Access Compliance Report

Public Rights-of-Way

(Curb Ramps)

Intersection ID: 42359	Main Street: HERON_GLEN_DR	Cross Street: WRENS_NEST_LN	Location: E
ADA ID: CDFE37101788	Ramp Type: PerpDiag	Initial Pass/Fail: Fail	Overall Compliance: No
Severity Score: 25			
Codes/Mitigation Info/Possible Solution		Field Measurements/Component Compliance

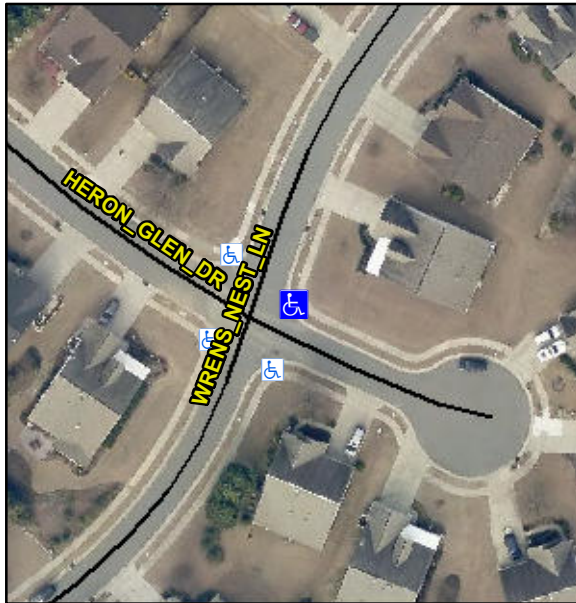
R304.5.3

Compliance	Description	Data	Compliance	Description	Data
N/A	Ramp Length (in)	46.0	Yes	Ramp Slope (%)	5.0
Yes	Ramp Width (in)	70.0	No	Ramp XSlope (%)	7.7
N/A	Flare Type LT	N/A	N/A	Flare Type RT	N/A
N/A	Flare Slope LT (%)	N/A	N/A	Flare Slope RT (%)	N/A
N/A	Flare Traversable LT?	N/A	N/A	Flare Traversable RT?	N/A
N/A	Landing Length (in)	N/A	N/A	DWS Provided?	N/A
N/A	Landing Width (in)	N/A	N/A	DWS Contrast?	N/A
N/A	Landing Slope (%)	N/A	N/A	DWS Length (in)	N/A
N/A	Landing X Slope (%)	N/A	N/A	DWS Full Width?	N/A
N/A	Landing Curb? (Y/N)	N/A	N/A	DWS Offset (in)	N/A
N/A	Shared Landing?	N/A			
N/A	Gutter Ponding?	N/A	N/A	Gutter Slope (%)	N/A
N/A	Gutter Lip Ht (in)	1.0	N/A	Gutter X Slope (%)	N/A
N/A	Painted X Walk1?	No	N/A	Painted X Walk2?	No
	X Walk 1 Direction	To NW		X Walk 2 Direction	To SW
N/A	X Walk 1 Width (in)	N/A	N/A	X Walk 2 Width (in)	N/A
	X Walk 1 Slope (%)	5.5		X Walk 2 Slope (%)	1.9
	X Walk 1 X Slope (%)	1.2		X Walk 2 X Slope (%)	3.1

Remove & Replace Curb Ramp With Two New Directional Ramps or Equivalent.
